# DAB-4c/DAB-4s Release Notes

Version 1.35.4  
03.03.2026

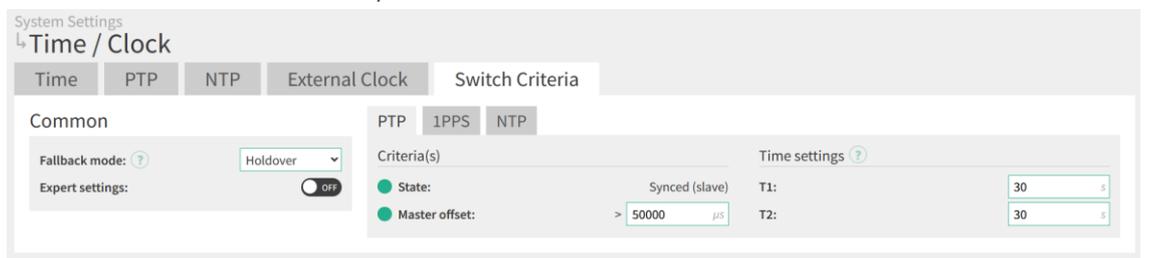
- The PTP functionality did get a complete revision, as it was not working reliably. In the course of these changes we did also revise the way to configure everything related to time and clock handling including NTP and external clock. Before this revision several menu options were involved in the configuration. The selection of interfaces, on which PTP should be enabled was done via the “Network Settings / Services” menu. The PTP configuration itself (e. g. domain number and delay mechanism) was done via the “Settings / External Clock” menu (but only allowing to use the same configuration for all interfaces enabled for PTP). NTP configuration was done via “Network Settings / NTP”, time configuration (time zone) via “System Settings / Time. All these configuration options are now consolidated into a single place – the menu “System Settings / Time/Clock”:

- You still have to configure via the “External Clock” tab (which corresponds to the former “Settings / External Clock” menu), if and which external clock source (PTP, NTP, 10MHz) should be used for the clock synchronization.

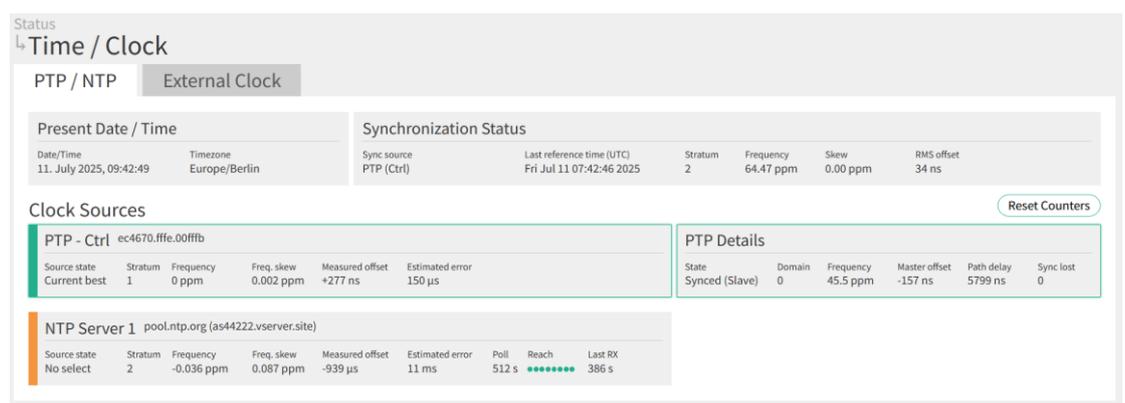
If a backup for the external clock is configured (e. g. NTP), the switch criteria are now configured via the “Switch Criteria” tab of the “Time / Clock” menu.

There’s also a new “Fallback mode” which allows you to control the behavior if all configured external clock sources do fail. In “Holdover” mode (the new default) the device will keep the last external clock (no longer regulated) and will not switch to the internal clock, which would always result in a glitch.

Generate settings file:

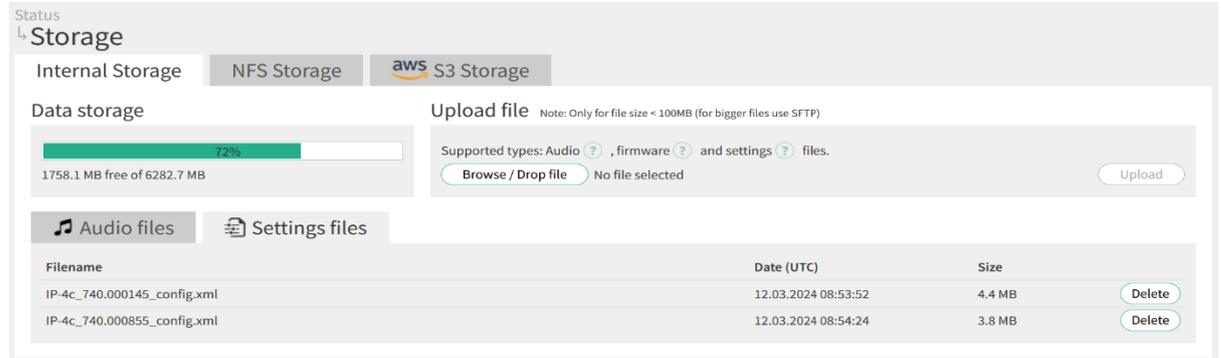
- Added event log entries when loading a settings file or loading factory settings
- When generating a settings file on the Global page you can now not just only download the file, but also save it to the internal storage. You can also directly change the name of the settings file.

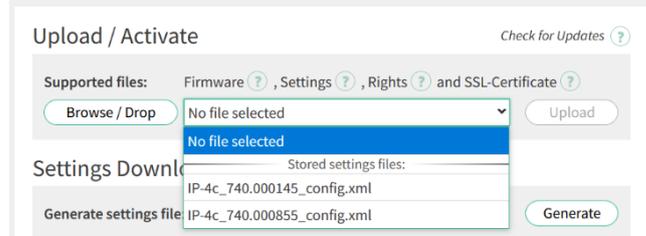
- Settings files can also be uploaded via the Storage page

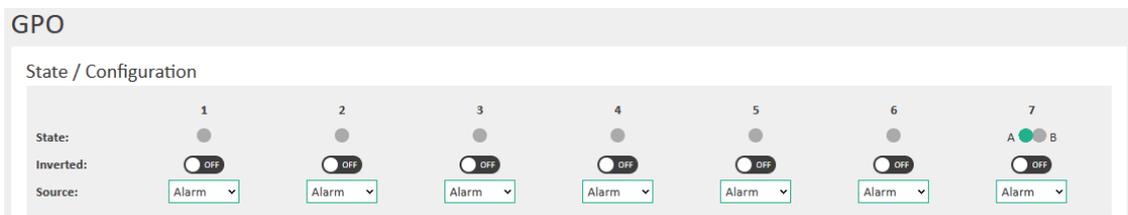
- Added Alarms as Source for GPO. (Output Relay)
-
